Change Order

No. 1

Project: 2026 Preservation Improvements to Mt. Moriah Cemetery	Owner: City of Deadwood	Owner's Contract No.:
Contract: A101-2017		Date of Contract: 3/16/2026
Contractor: Fuller Construction Company LLC		Engineer's Project No.: 2026-026

Description: Response to RFP additions for Site D-2 and D-7 plus additional contractor recommended work for sites D-1, D-2, D-3, D-4, D-7, D-8, D-9, D-12, D-17, D-21, D-22, D-23, D-27 and an addition of 5 days work time required.

2. 3rd Addition, Section 1, Plot 55, Unknown, Sheet D-7

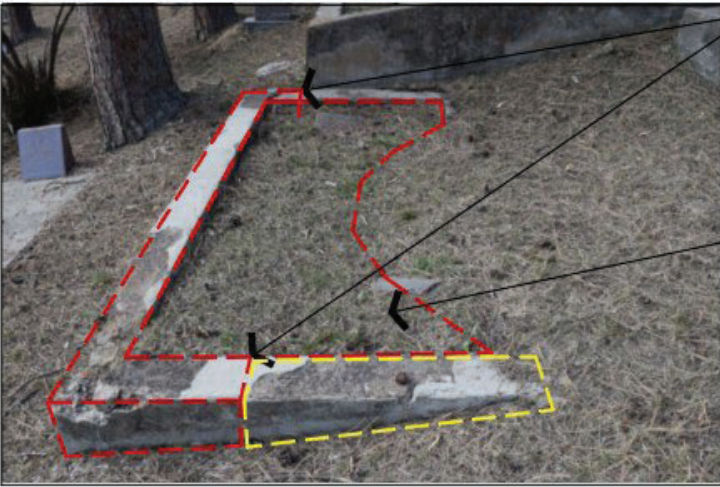
- Extend wall replacement to cover full wall on the east side of the plot – see area in yellow in the image below
- Document with photographs, the removal of the stone monument from soil and report to Kevin Kuchenbecker. If the monument is a headstone, after documentation by the City, replace per Detail 1, Sheet D-28

**3rd ADD, SEC 1
 PLOT 34 JOHNSON**

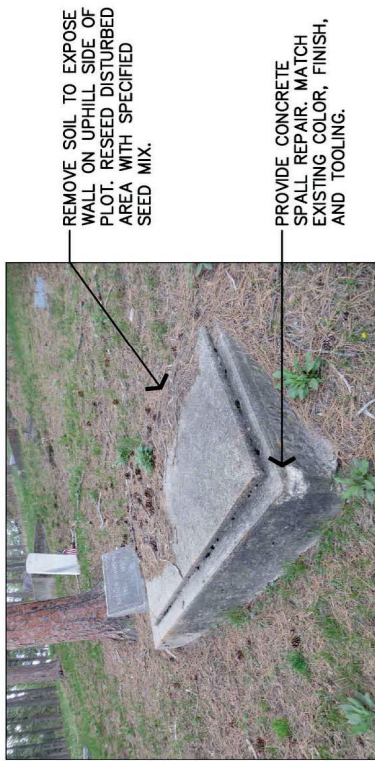
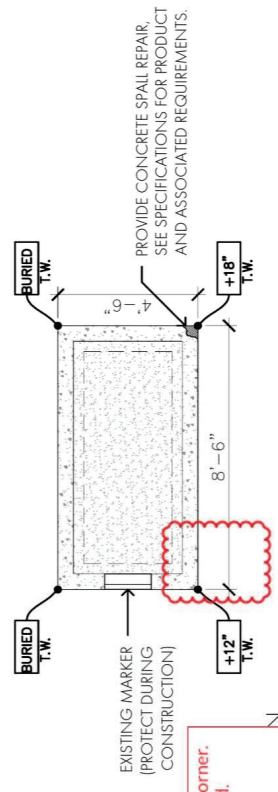
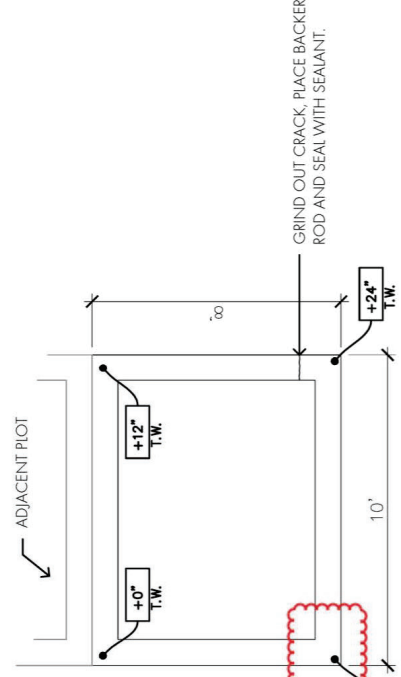
Additional damage on this corner. More patch repair is needed.

Cracking along this corner as well.
Routed, cleaned and sealed roughly 2'

3rd ADD, SEC 1 PLOT 50
WALDSCHMIDT

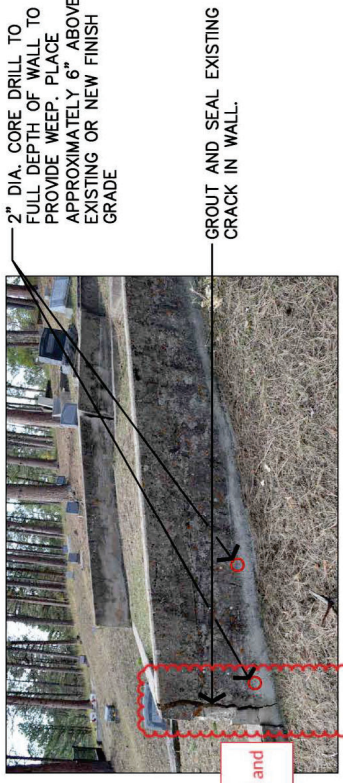
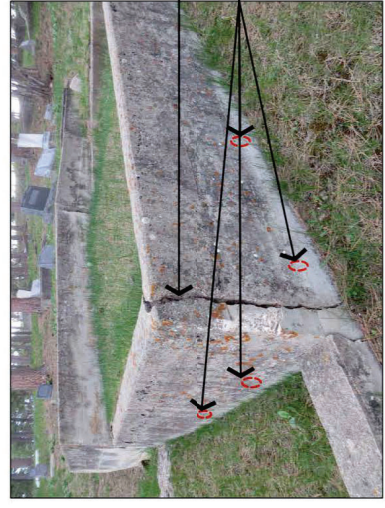
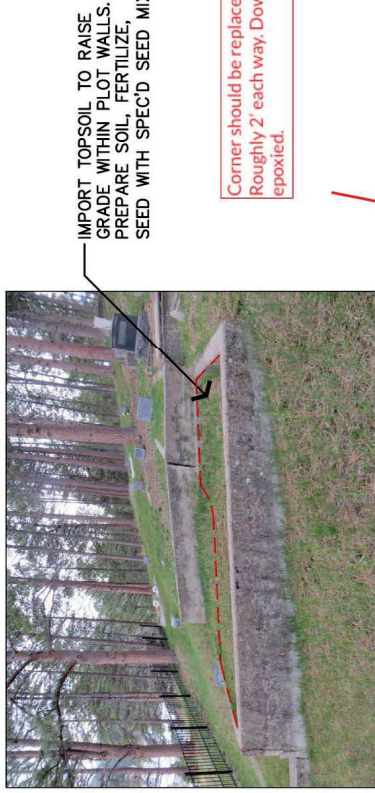
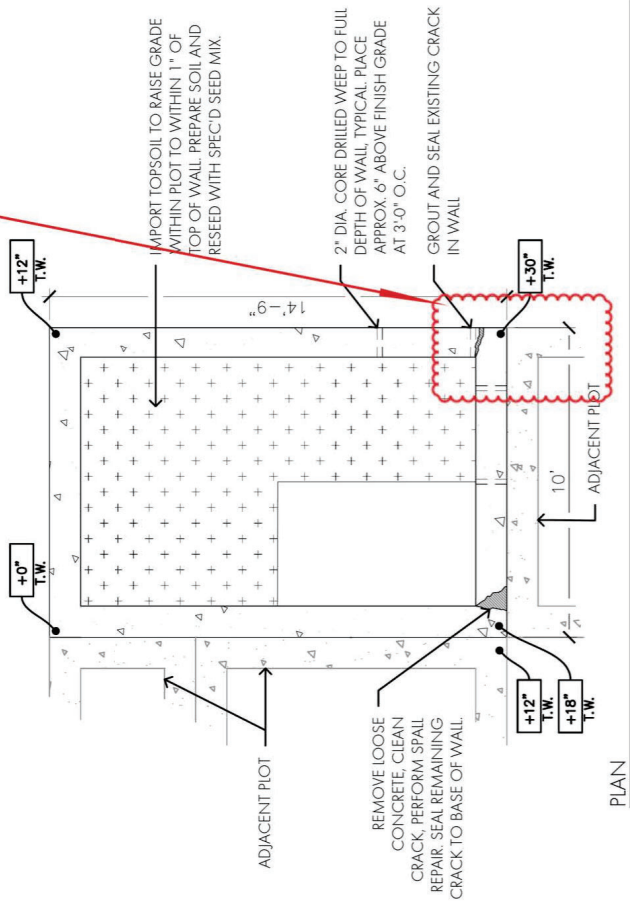
Corner should be replaced. Roughly 2' each way. Doweled and epoxied.

3rd ADD., SEC 1
PLOT 85 HANSEN

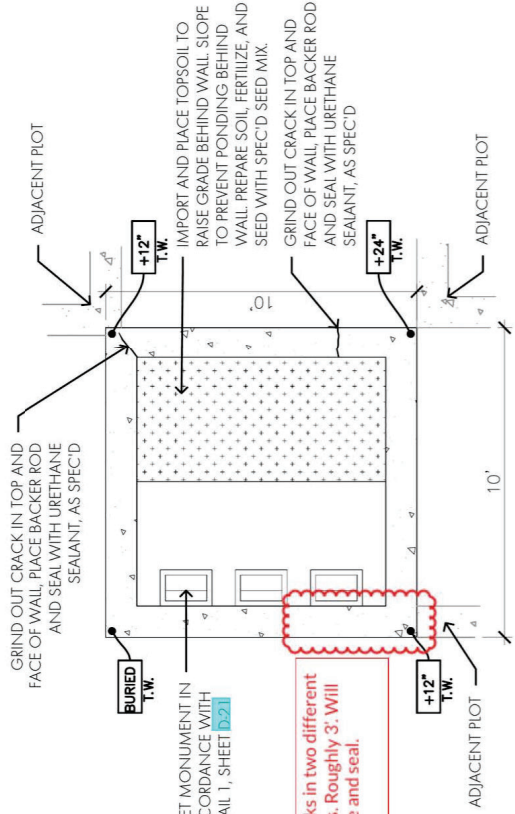
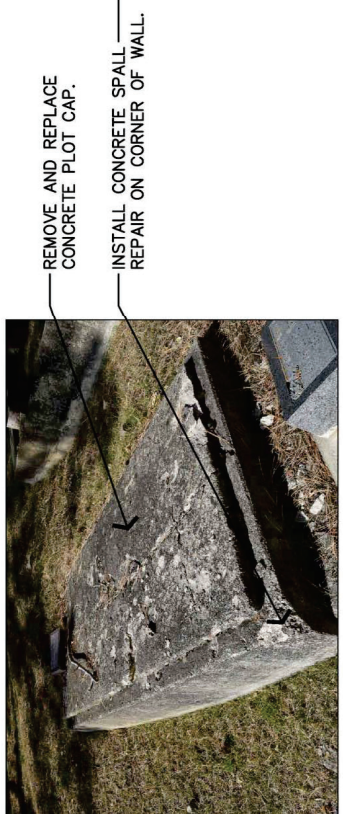
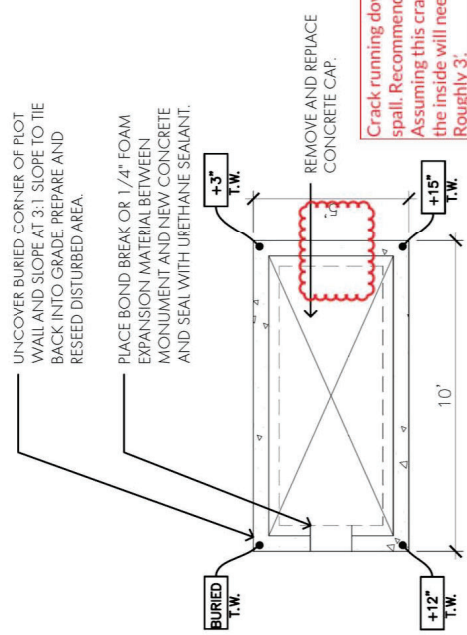
Crack running down wall and minor spall. Recommend routing and sealing. Assuming this crack runs through wall the inside will need sealed as well. Roughly 3'.

3rd ADD, SEC 1
 PLOT 109 ISLAND

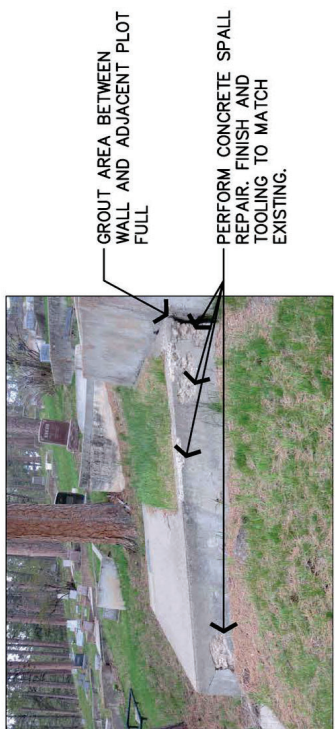
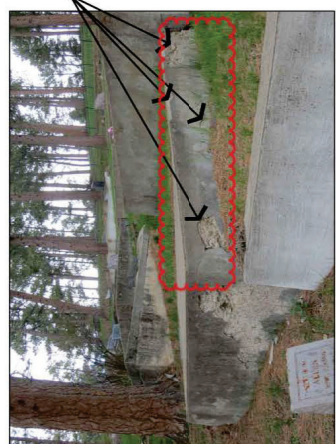
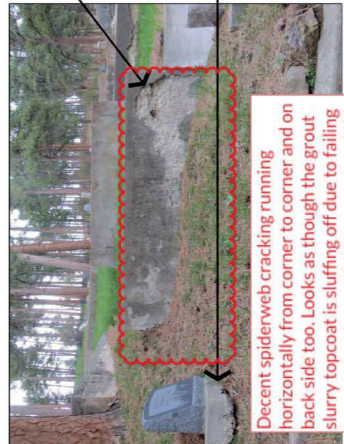
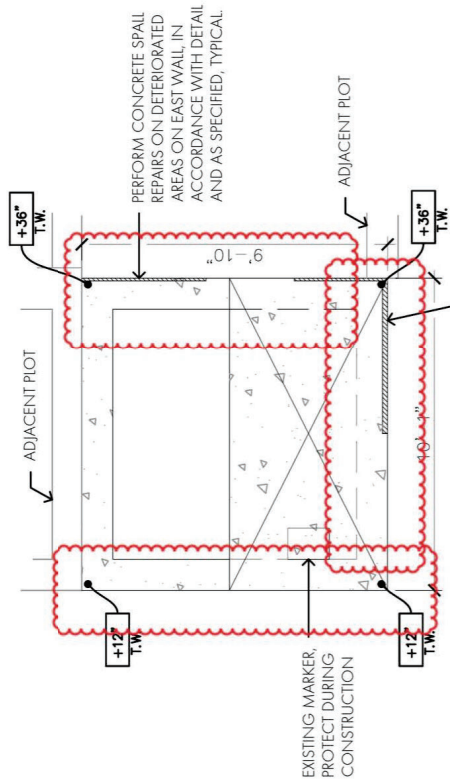
Decent spiderweb cracking running horizontally from corner and on back side too. Looks as though the grout slurry topcoat is sluffing off due to failing concrete underneath. We can cut and chip 2-3" off walls and build a new 4-5" wall to in capsule monument on 3 sides.

2026 PRESERVATION
 IMPROVEMENTS TO
 MOUNT MORIAH
 CEMETERY
 DEADWOOD, SD
 3rd ADD, SEC 1
 PLOT 119
 SCHARTZ

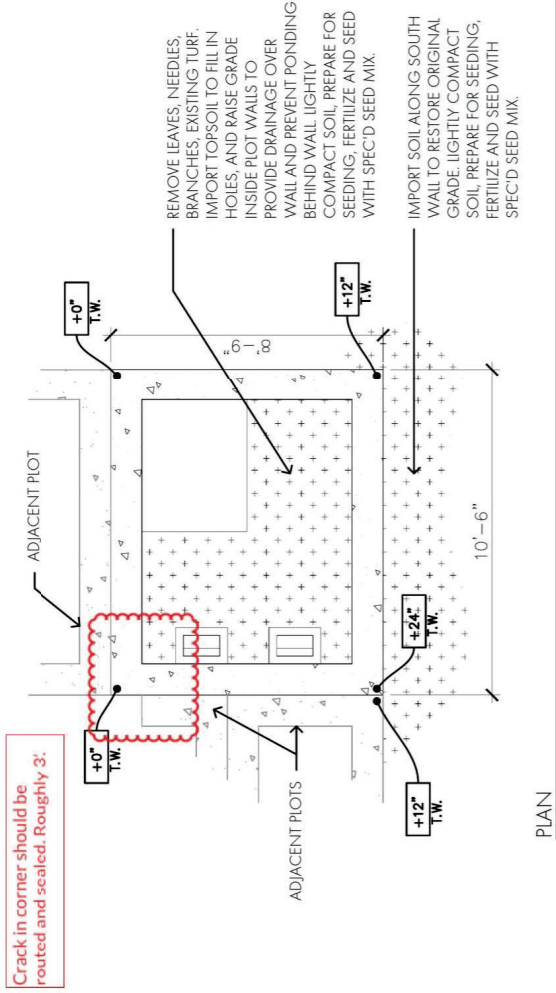
Crack in corner should be routed and sealed. Roughly 3."

3rd ADD, SEC1
 PLOT 114 PHILLIPS

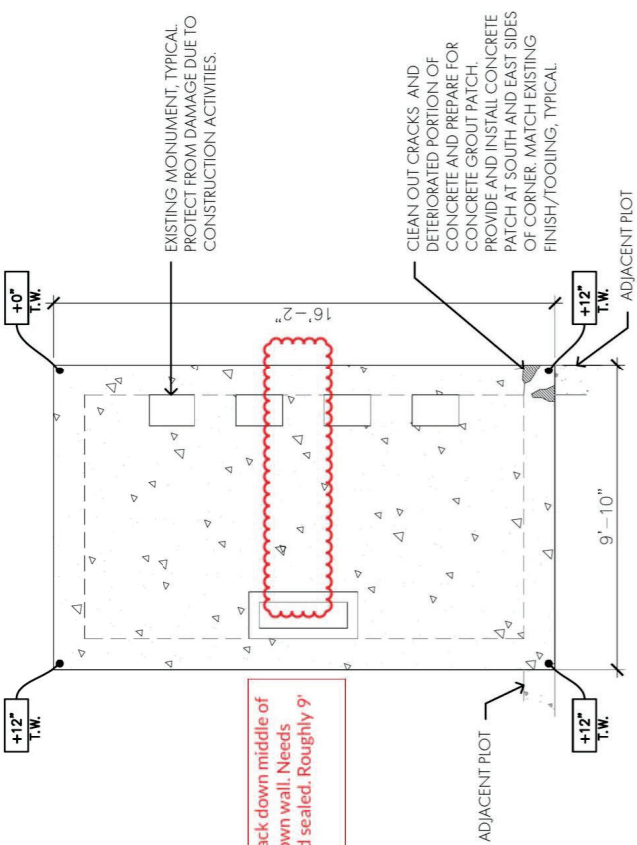
Decent crack down middle of cap and down wall. Needs routed and sealed. Roughly 9'
